April 26, 2022
Medway Planning & Economic Development Board
Meeting

Public Hearing Continuation
Phytopia – 6 Industrial Park Road
Site Plan, Reduced Parking Special
Permit and Groundwater Protection
Special Permit

**Subject: Response to October 27, 2021 review comments from Tetra Tech
Phytopia, Inc.
Major Site Plan Review
6 Industrial Park Road
Medway, Massachusetts**

**Re: Phytopia Inc.
 Major Site Plan Review
 6 Industrial Park Road
 Medway, Massachusetts**

SHEET 1 OF 14

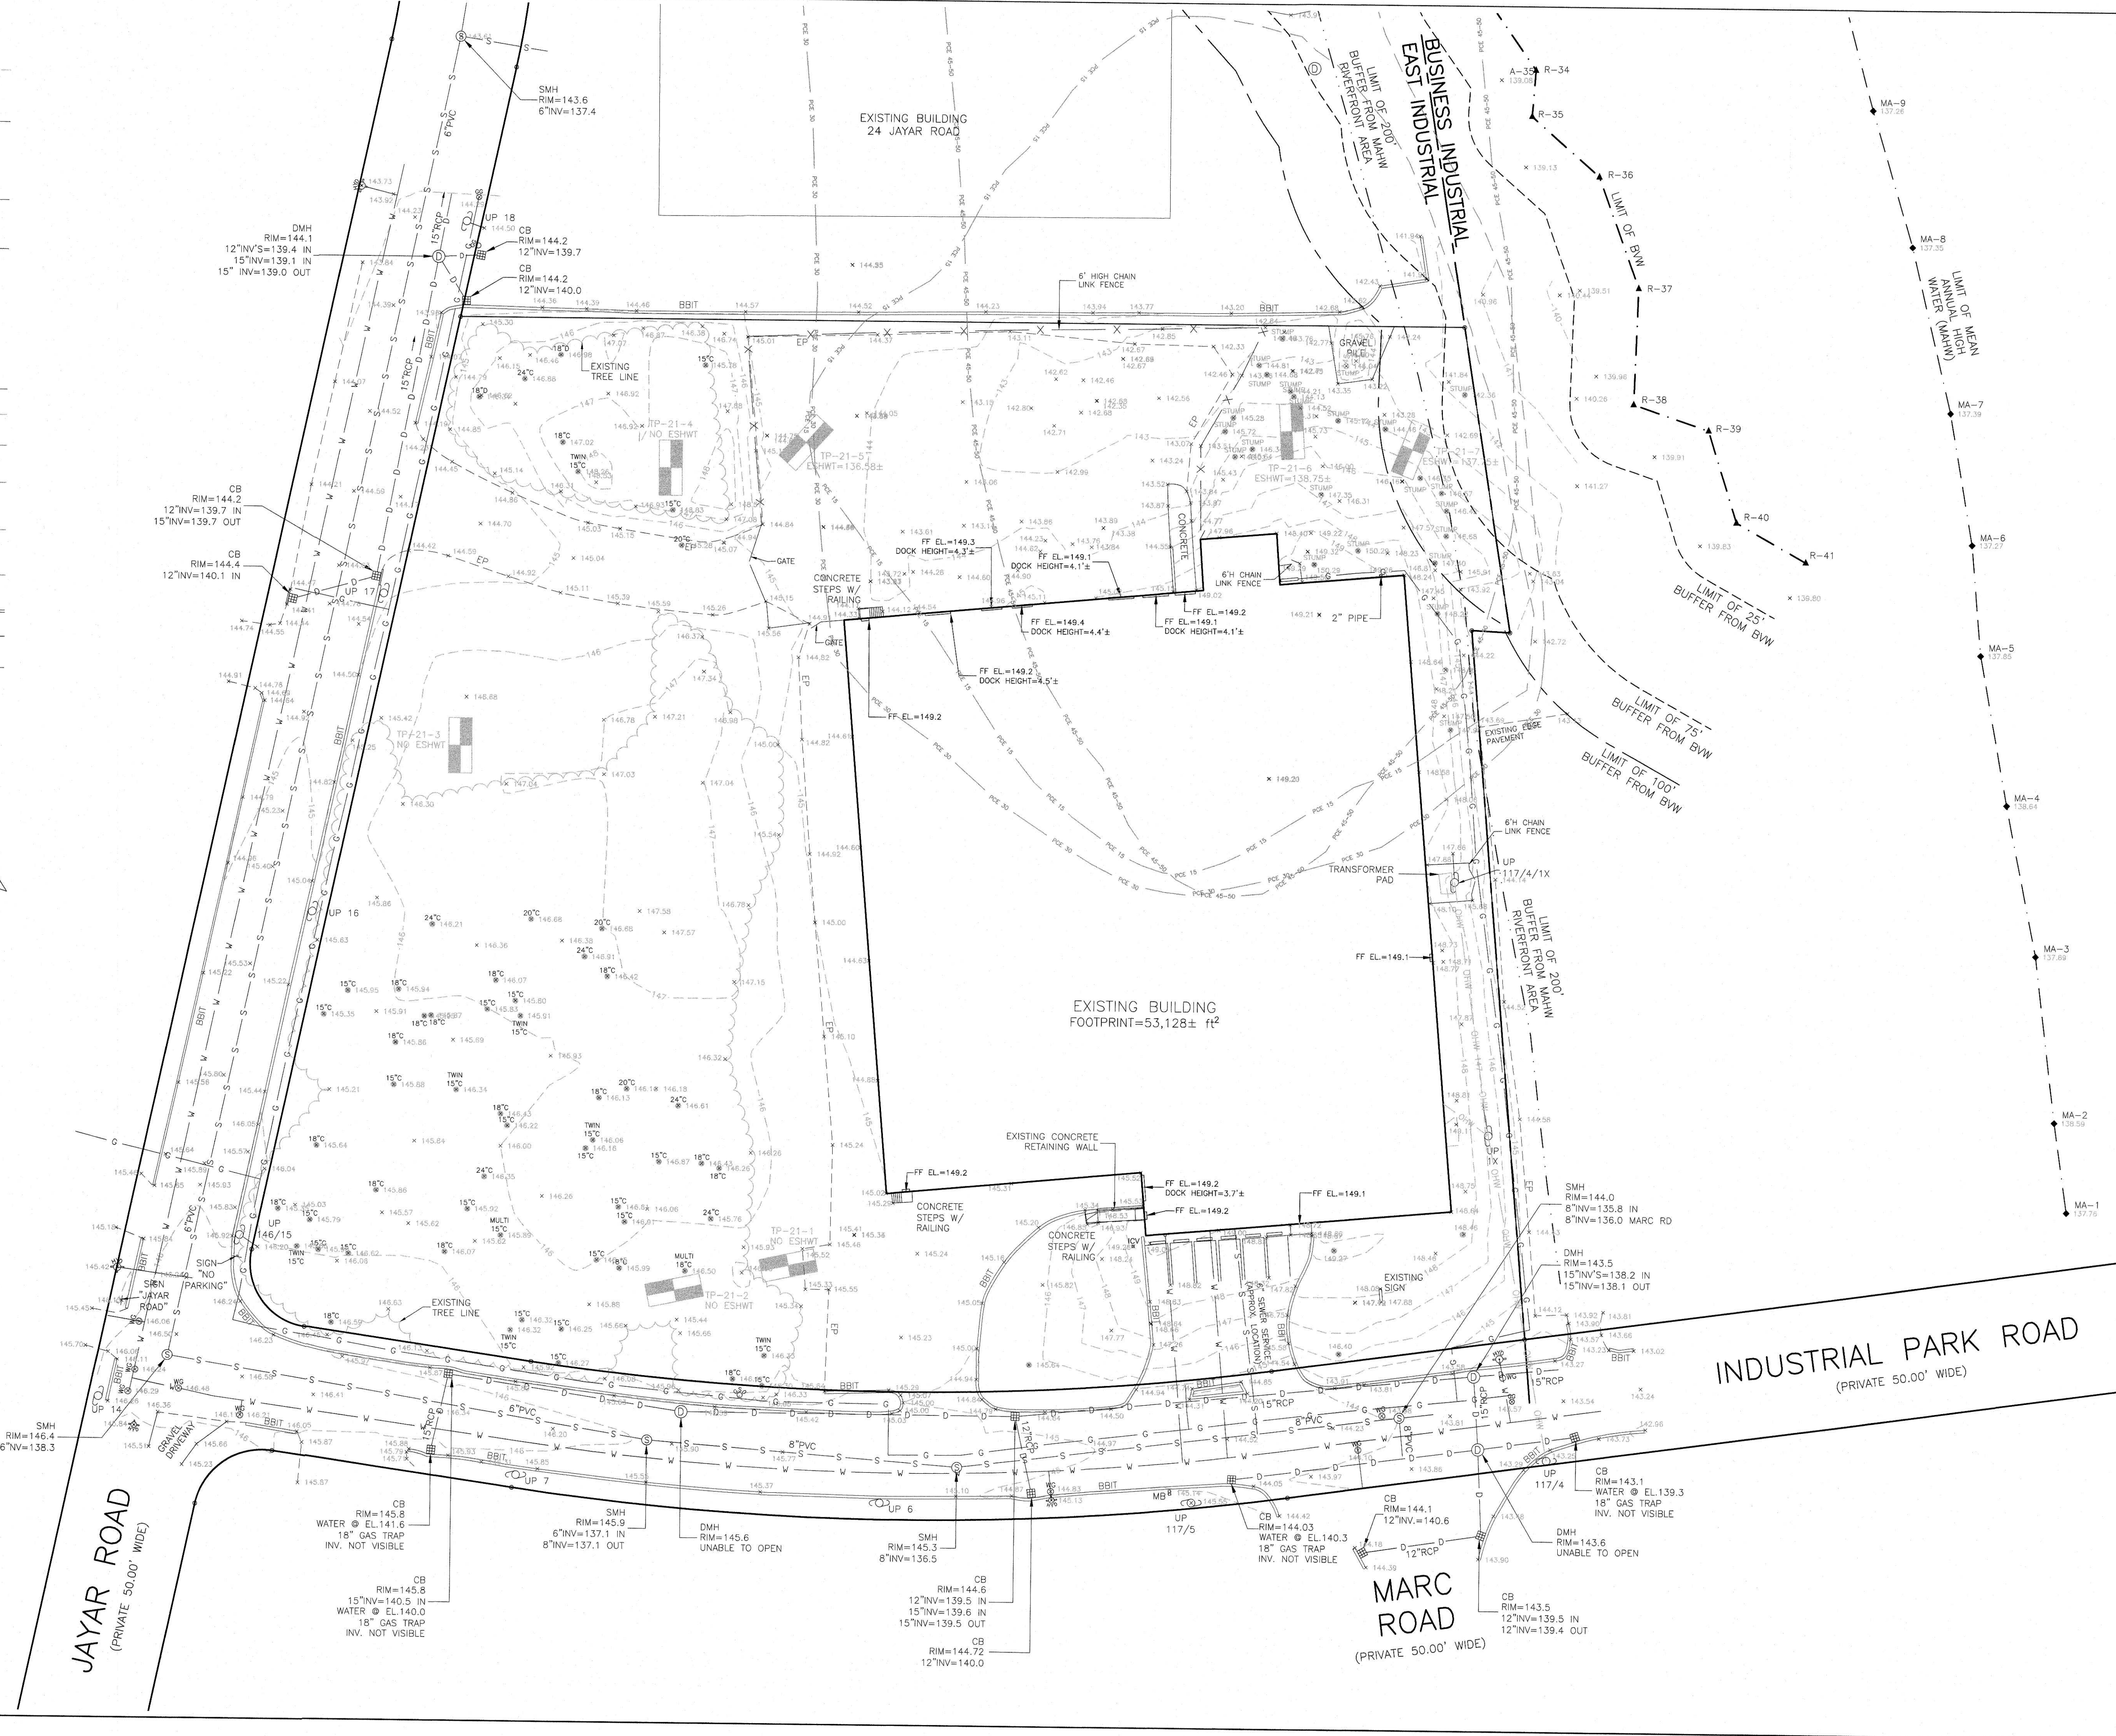
6. Cover sheet has not been provided in the Plans. However, applicable cover sheet information is provided on the Site Context Sheet/Location Plan. A list of requested waivers should be added to the sheet once approved by the Board. (Ch. 200 §204-5.A)

TT 10/27/21 Update: The list of requested waivers has not been included on the Cover Sheet.

6. Cover sheet has not been provided in the Plans. However, applicable cover sheet information is provided on the Site Context Sheet/Location Plan. A list of requested waivers should be added to the sheet once approved by the Board. (Ch. 200 §204-5.A)

- *WSE 10/12/21 Response: A cover sheet with a list of waivers has been provided, see sheet 1 of 10.*
 - **TT 10/27/21 Update: The list of requested waivers has not been included on the Cover Sheet.**

The list of requested waivers has been added to Sheet 1, the Cover Sheet.

- *WSE 4/12/22 Response: The list of requested waivers has been added to Sheet 1, the Cover Sheet.*
 - **TT 4/22/22 Update: In our opinion, this comment is resolved.**
